**Southern
Water**

Your ref
BN/112/20/EIS

Proposal: Environmental scoping opinion for up to 1500 dwellings, community facilities, local centre (shops and services), a primary school and associated playing fields and early years provision (nursery).

Site: BN/112/20/EIS: - Land at Barnham, Eastergate and Westergate, PO22 0ED.

Printed By: kishoku

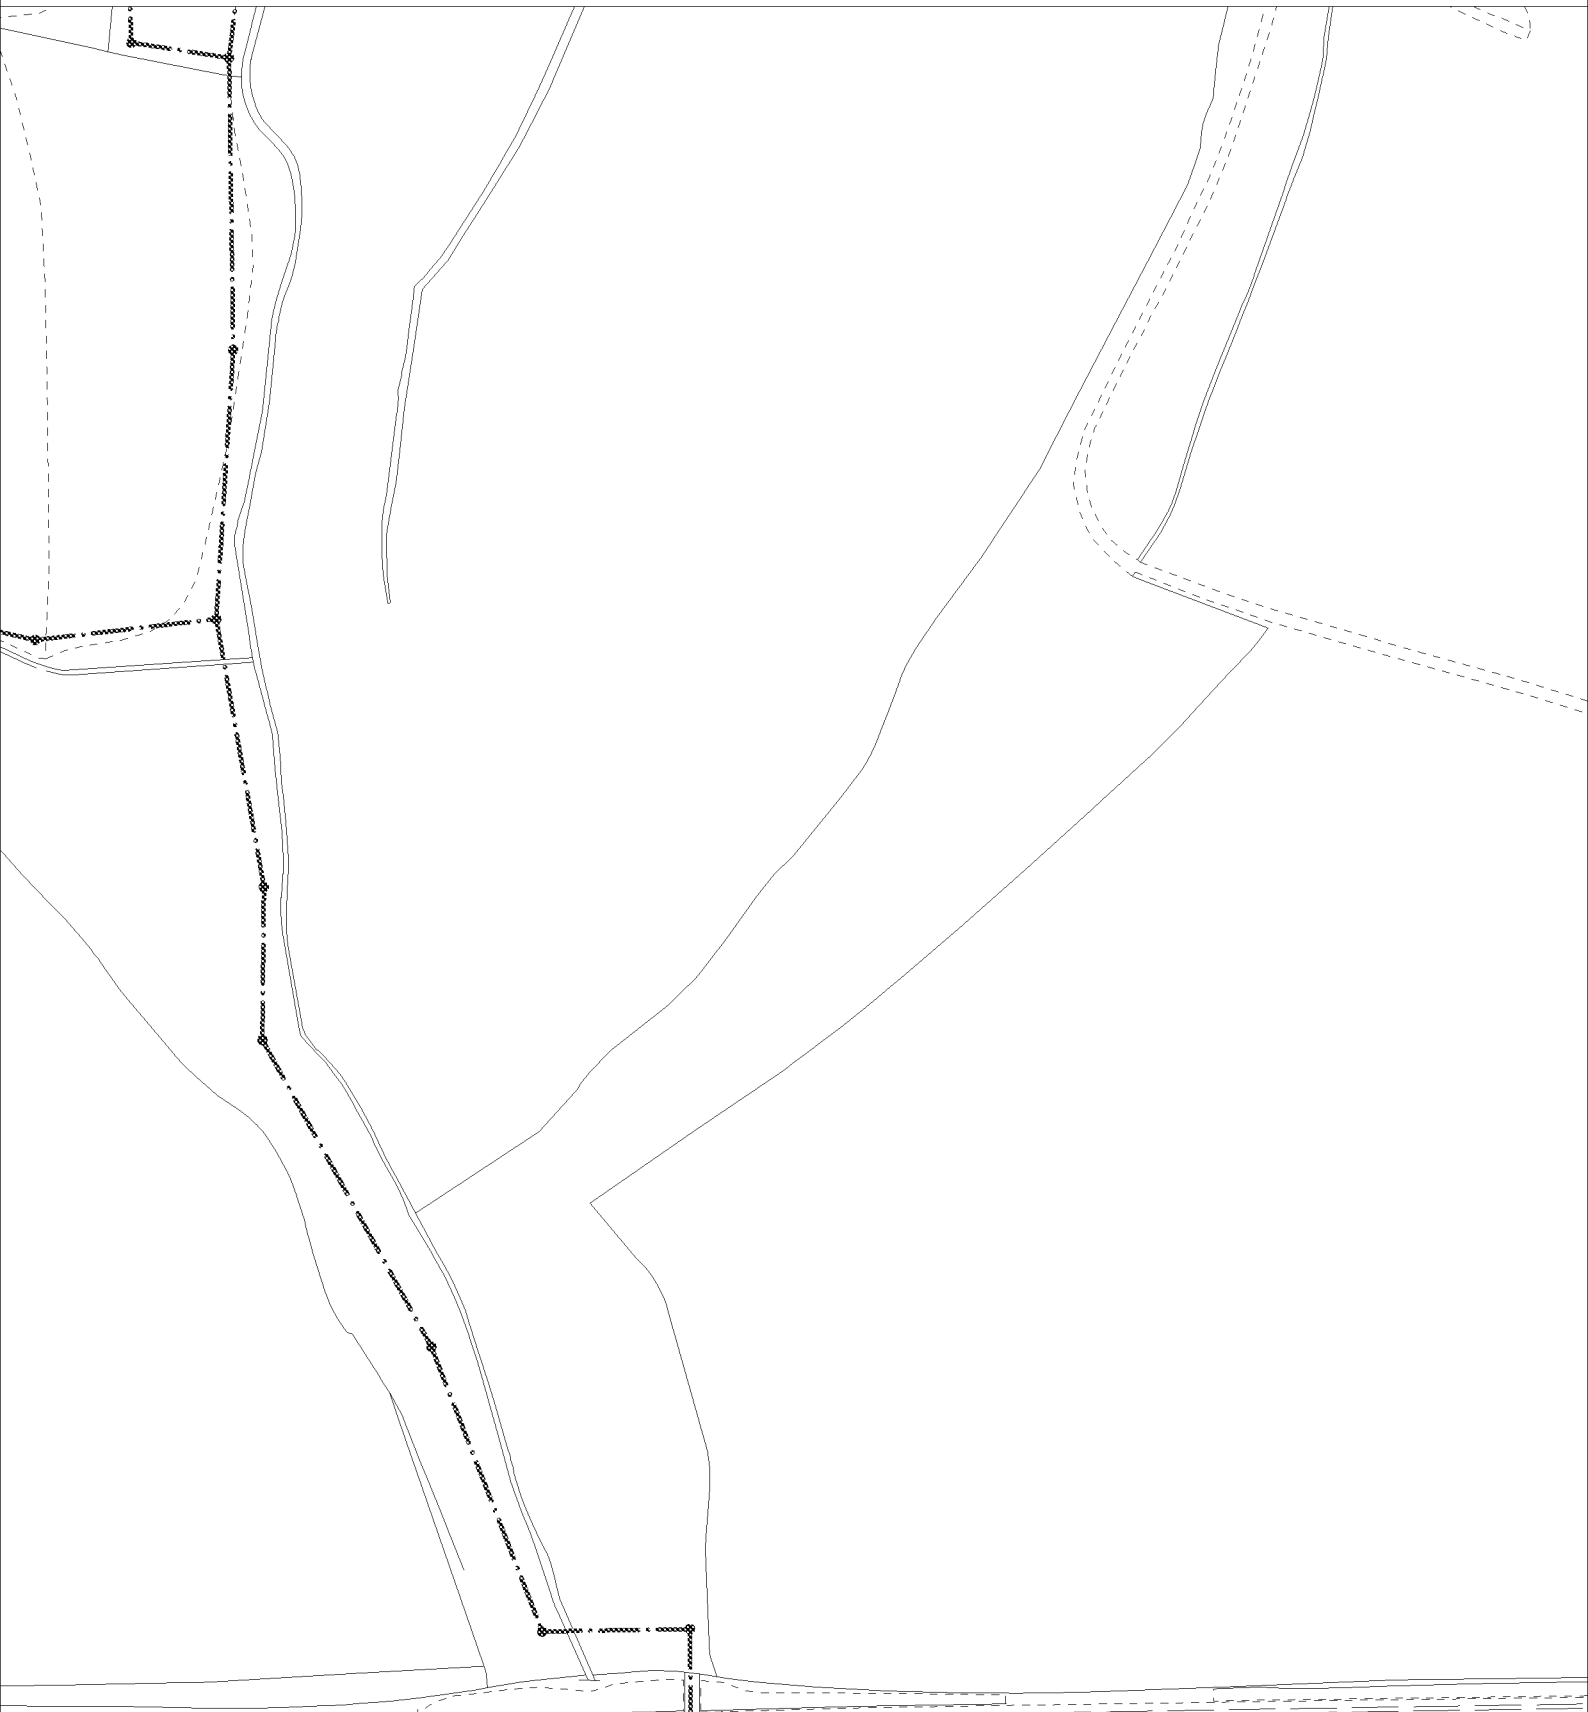
- Southern Water's current sewerage records show that there are foul sewers within the proposed development site/s. No new development/building works will be permitted to be constructed over or within 3.0 metres of the existing foul sewers. Sewer record attached for your information.
